Palo Verde Nuclear
Generating Station

**Subject: Palo Verde Nuclear Generating Station (PVNGS)
Units 1, 2, and 3
Docket Nos. STN 50-528, 50-529 and 50-530
Correction to Response to Request for Additional Information for the
Review of the PVNGS License Renewal Application (LRA), and LRA
Amendment No. 30**

**Correction to Response to Request for Additional
Information Regarding Steam Generators**

**Palo Verde Nuclear Generating Station
License Renewal Application
Amendment No. 30**

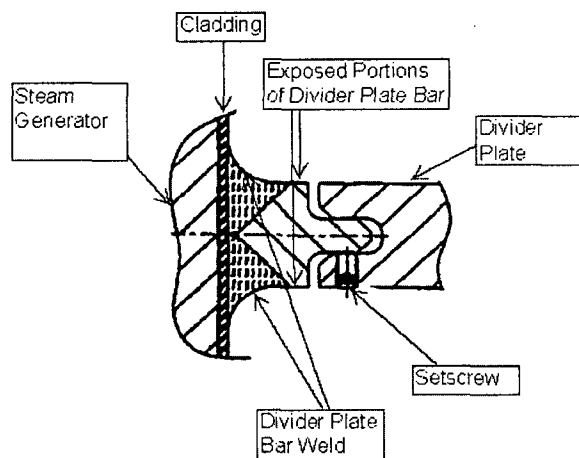
In order to address potential primary water stress corrosion cracking (PWSCC) of the Unit 2 Alloy 600 SG divider plate bars, Commitment No. 61 in LRA Table A4-1 has been expanded, as shown in LRA Amendment No. 30 in Enclosure 2, to include the Unit 2 SG divider plate bars within the scope of the committed analyses, and the exposed portions of the Unit 2 SG divider plate bars within the scope of the committed inspections. The diagram below shows the exposed portions of the divider plate bars that would be accessible for inspection.

Inspection or analysis of the screws is not being included in this commitment because any possible PWSCC that may occur in the screws would not be expected to propagate to the reactor coolant pressure boundary material.
